**NOTICE OF A REGULAR MEETING
BONDURANT PLANNING AND ZONING COMMISSION
AUGUST 26, 2021**

TITLE: Return to Table: PZ-210722-18: Considering recommended approval of the Top Farms rezoning from the Agricultural (A-1) District to the Planned Unit Development (R-5) District on property currently owned by Top Farms LLLP north of Park Side Plat 2 and adjacent to Highway 65; and recommended approval of the Future Land Use Map amendment from Single-Family Detached to Multi-Family and Commercial in areas shown on the PUD Conceptual Plan.

TITLE: PZ-210826-20: Considering recommended approval of the SKOL Trucking site plan at 2415 Robinson Avenue NE

C4 - Site Sheet

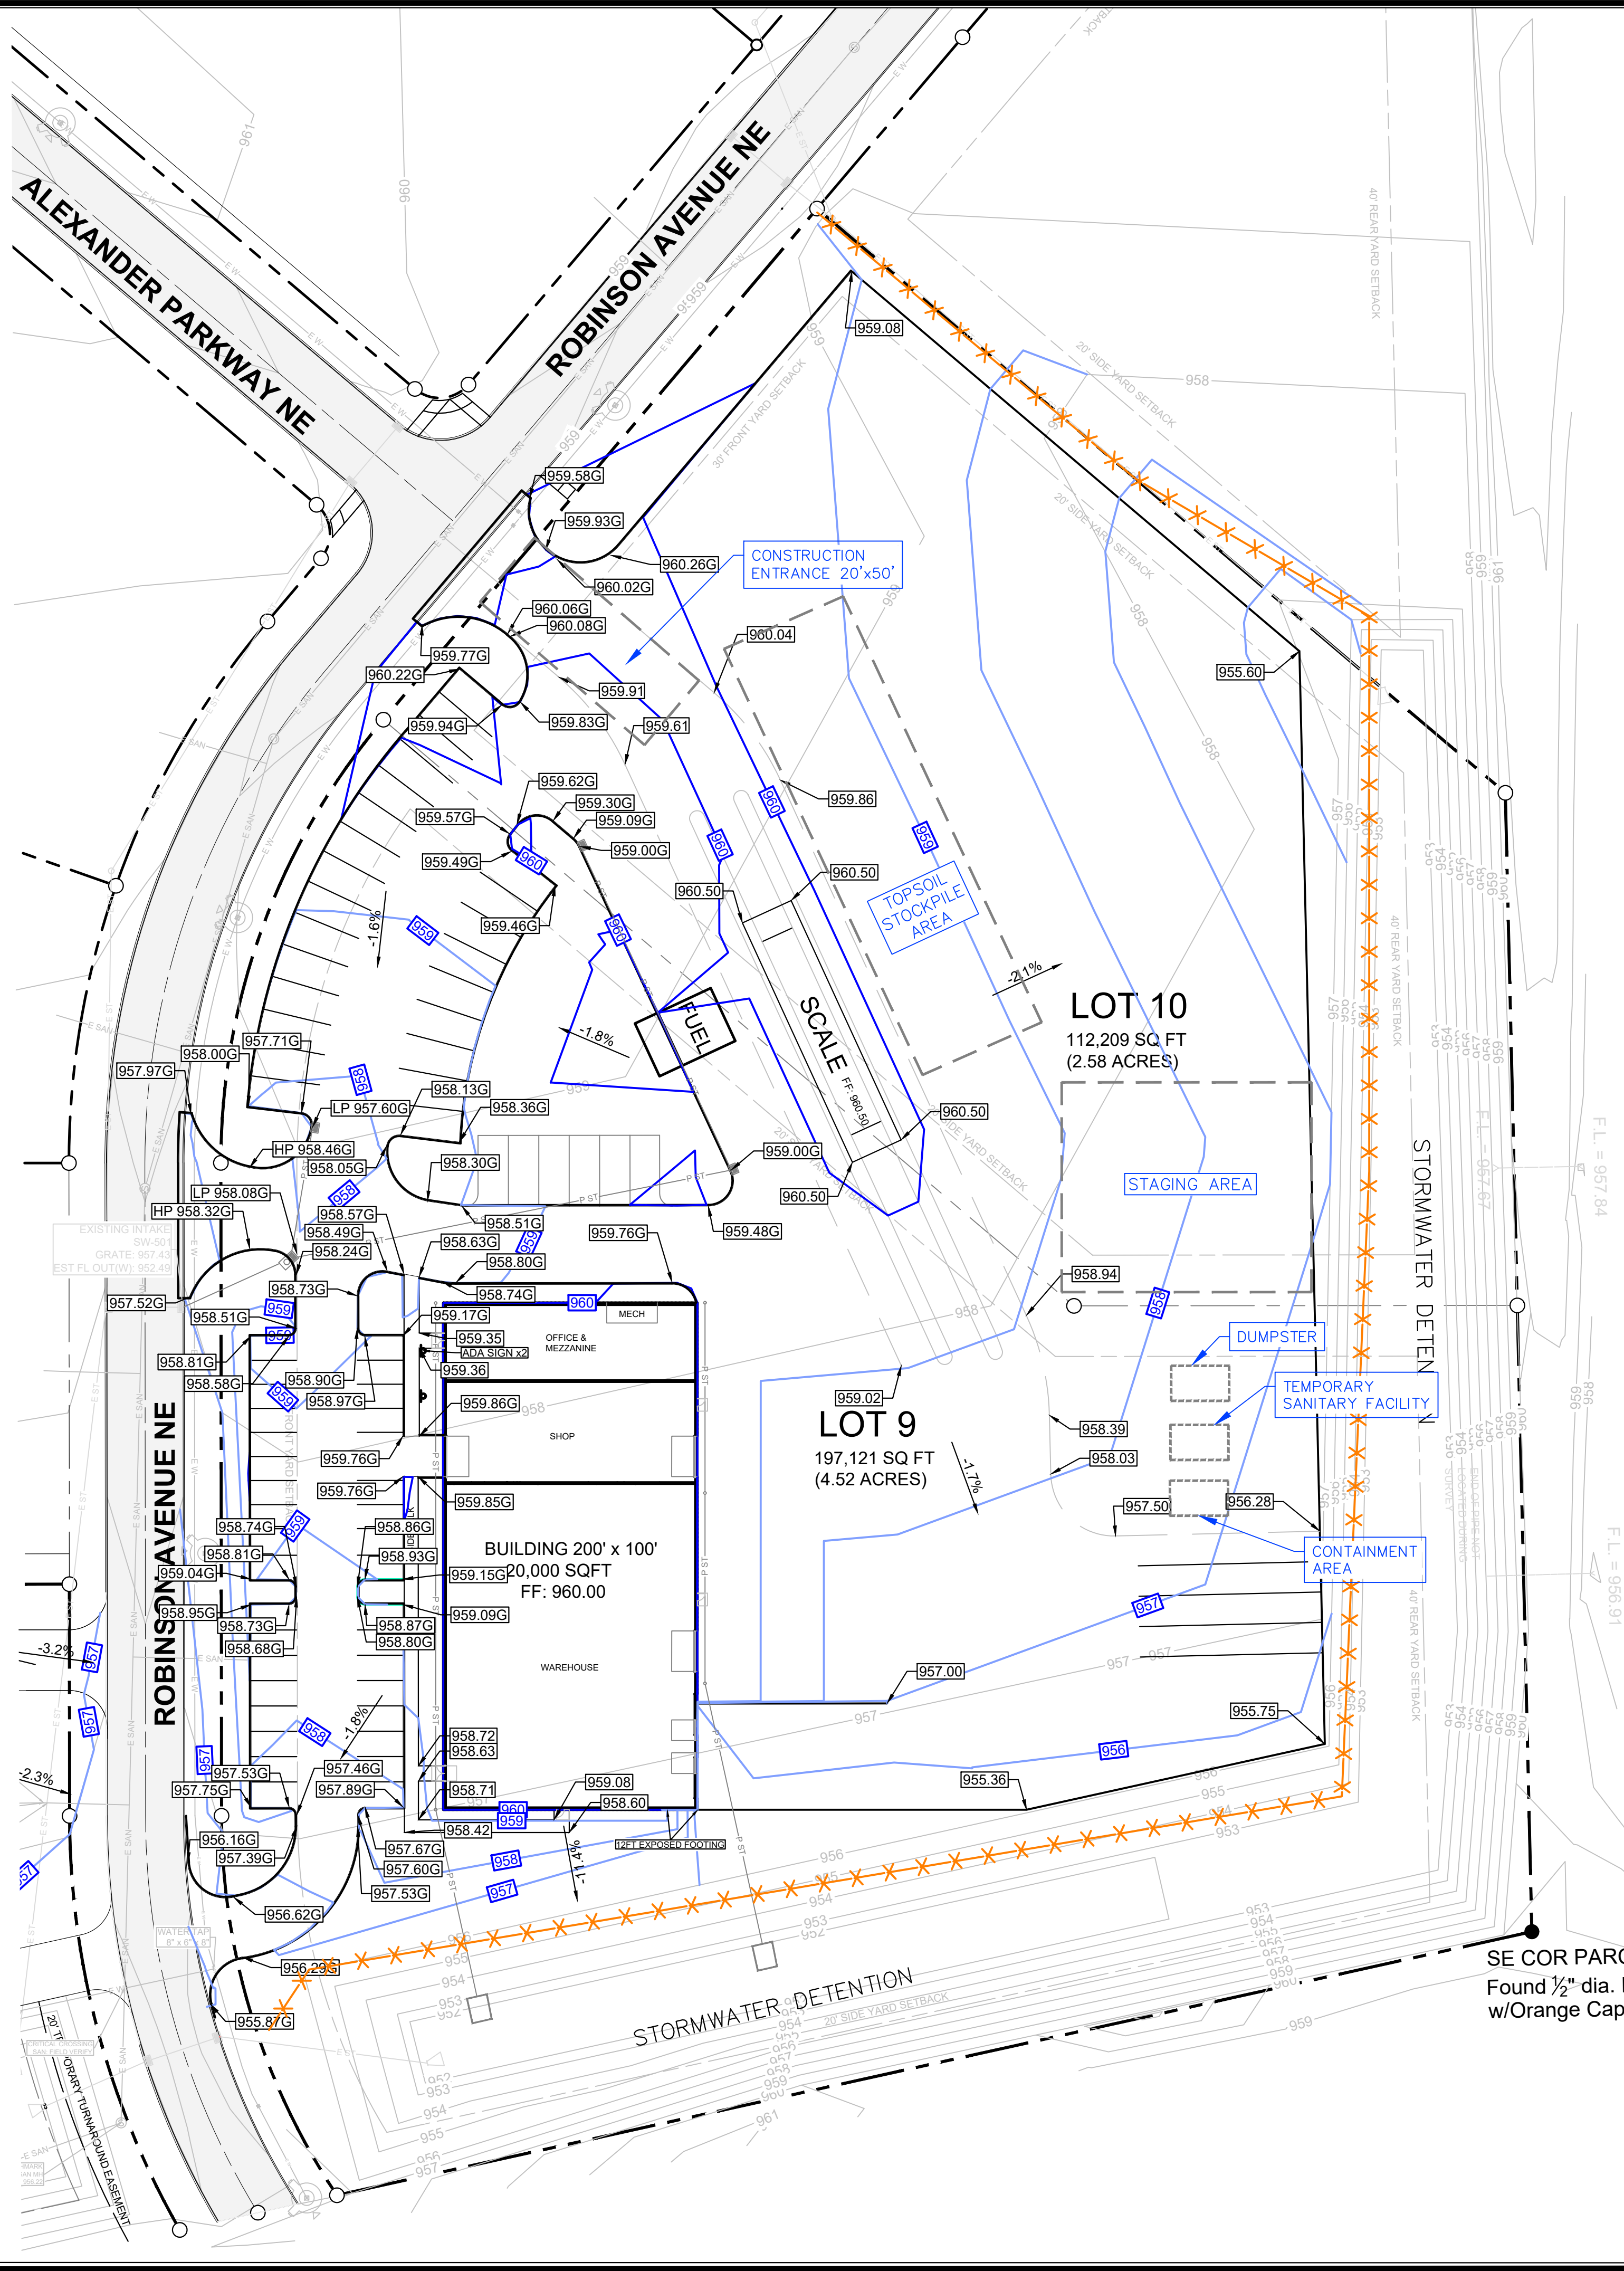
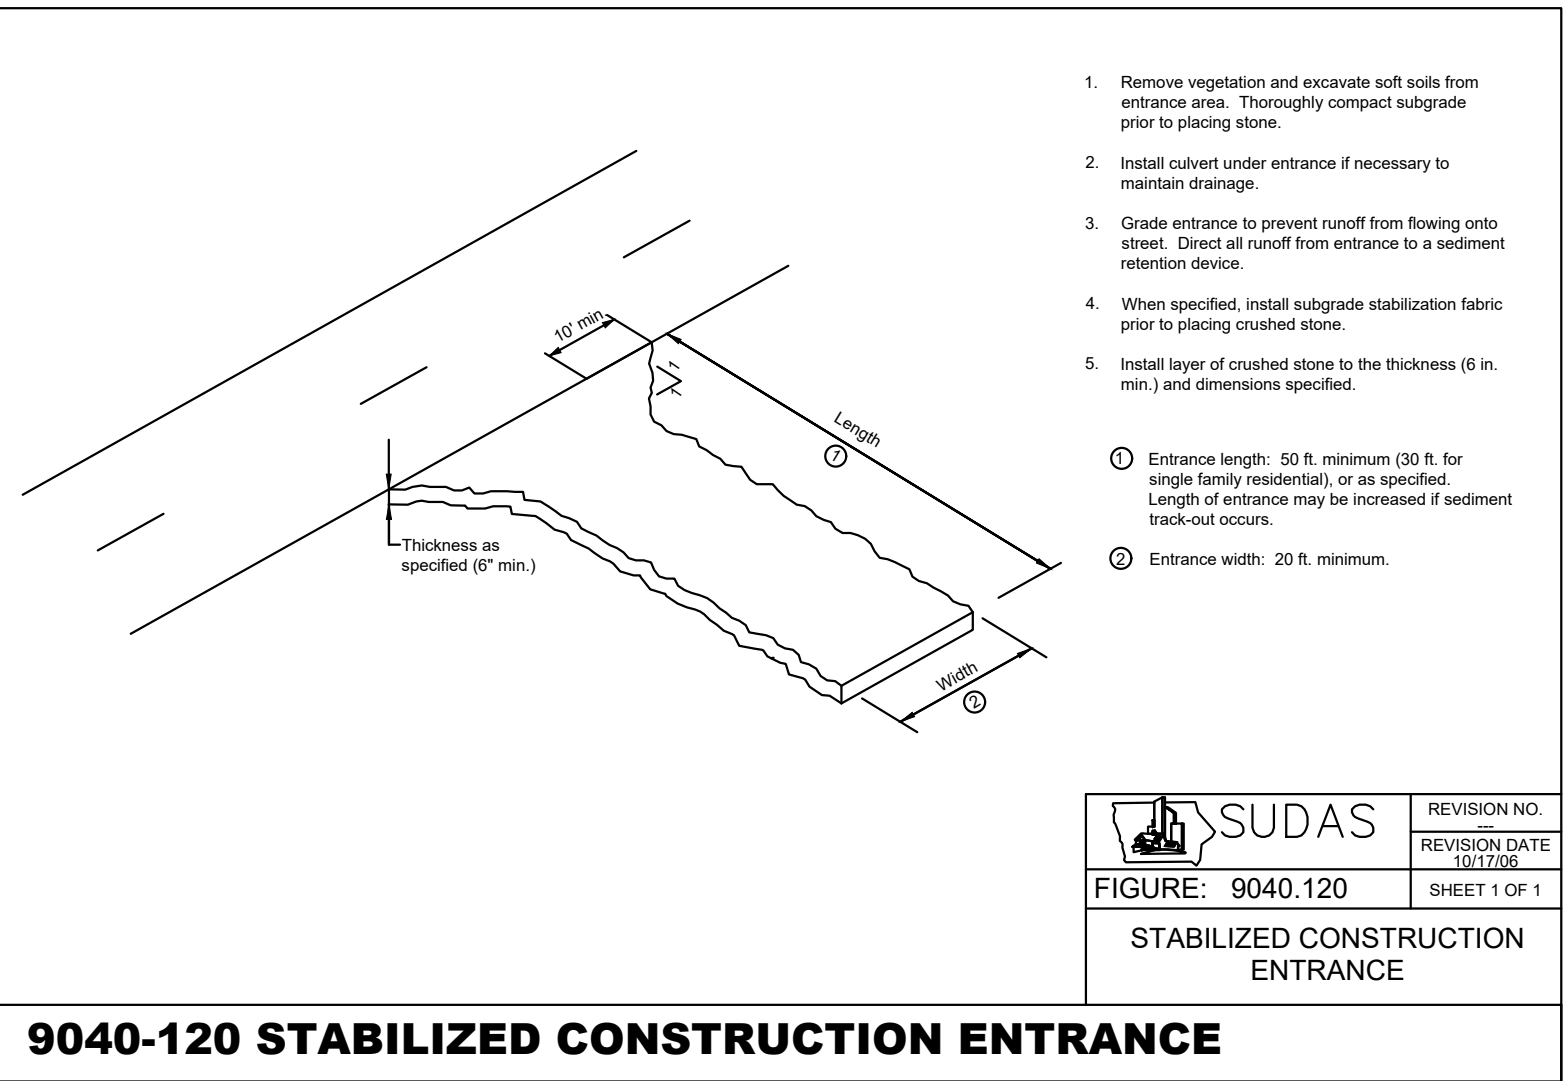
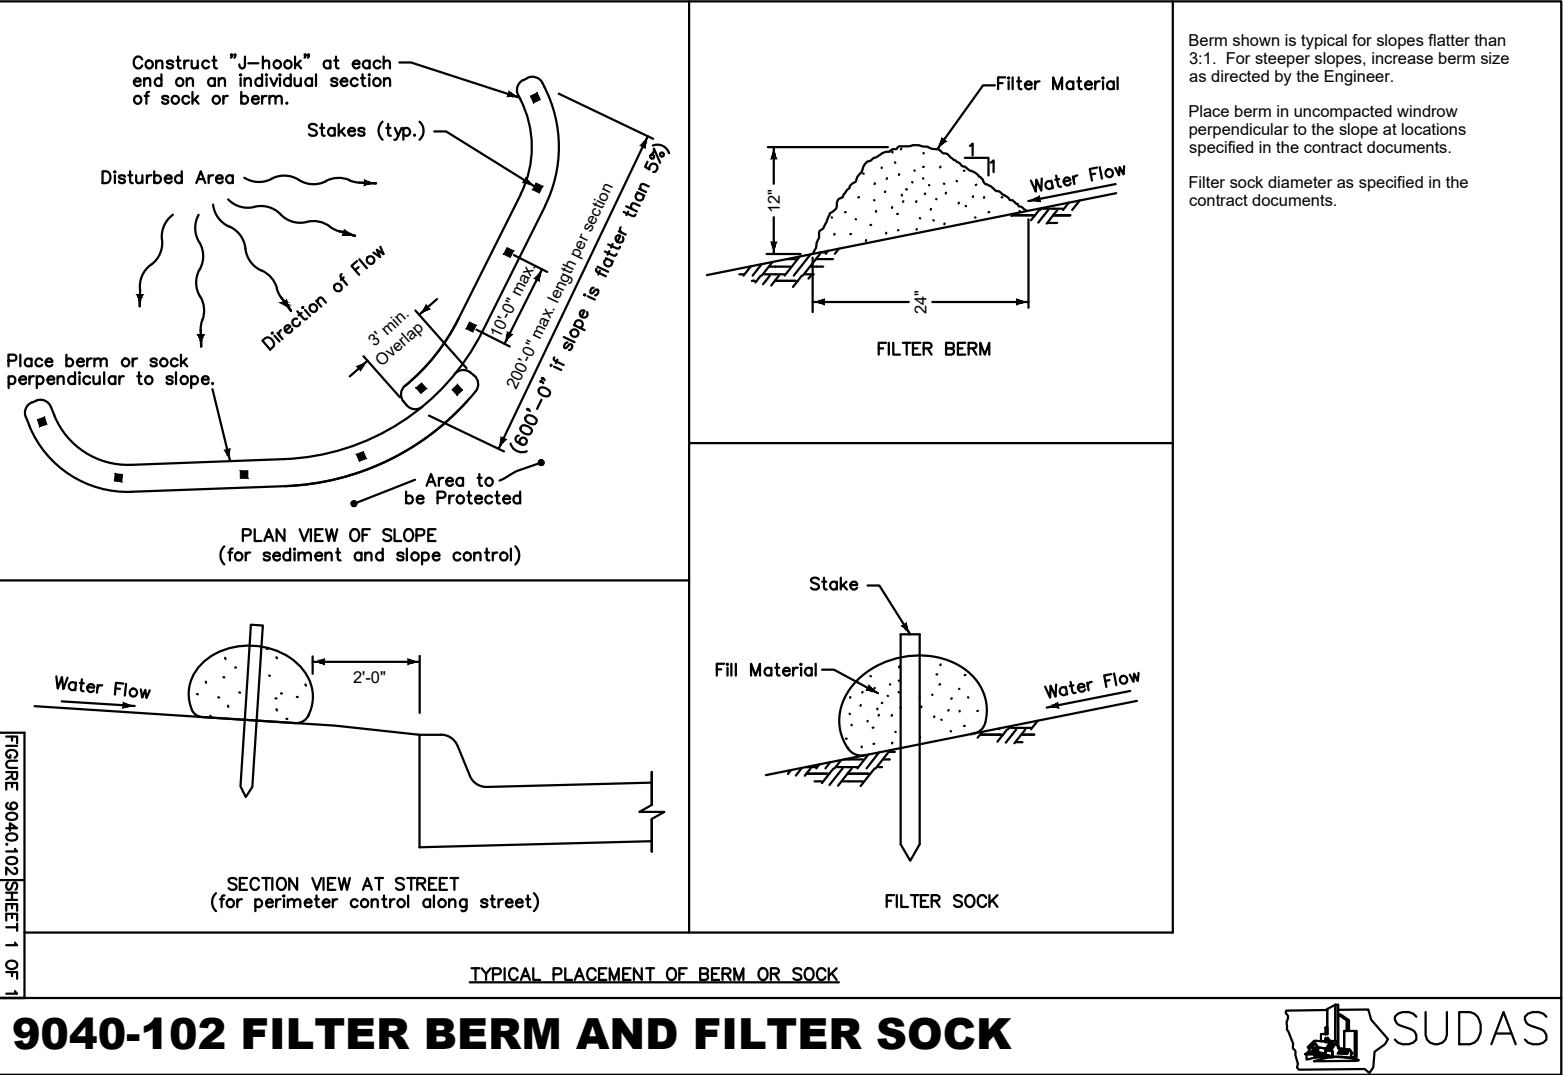
- Page C4 contains the required landscaping plan. Notes on this:
 - It appears the noted street frontage of 664' is incorrect. Site plan to be updated to note a corrected street frontage and general tree count requirement so that 1 tree per 50' of street frontage is met.

- Site plan to be updated to show/note that all trees within the required 30' front yard setback area will be planted at least 4' away from the front property line, as is required by Section 182.05.E.

- This site shows 57 parking spaces. $57/18 =$ at least 4 interior trees required. The landscaping plan shows 4 interior trees proposed.
 - The landscaping plan notes that deciduous shade and ornamental trees are proposed. The breakdown of trees proposed meets the type requirements as listed in Section 182.05.D.1.

- Further information has been requested so that the site plan shows/notes that 5% of the parking lot area will be interior greenspace, as is required by Section 177.10.7.A.
